SERVICE BULLETIN

APPLICABILITY: 2017MY Outback w/ Touring Package
 17MY Forester w/ Touring Package

NUMBER: 04-16-17

SUBJECT: Performance of Steering Wheel Heater Feature

- 1) Heated Steering Wheel switch
- 2) Indicator light
- 3) Heated area

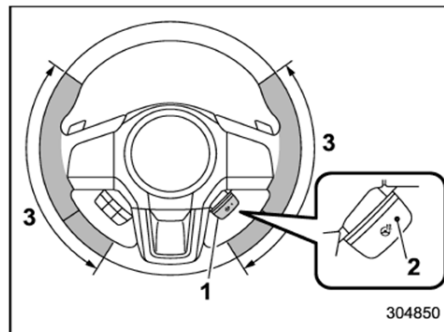
IMPORTANT: To avoid unnecessary replacement, the information below is provided showing the areas of the steering wheel which are heated. A lack of heat from areas marked “3”, when the Heated Steering Wheel switch is in the “ON” position, is the condition addressed in this bulletin.

After confirming the customer concern and determining steering wheel replacement is necessary, follow the procedure in the applicable Service Manual.
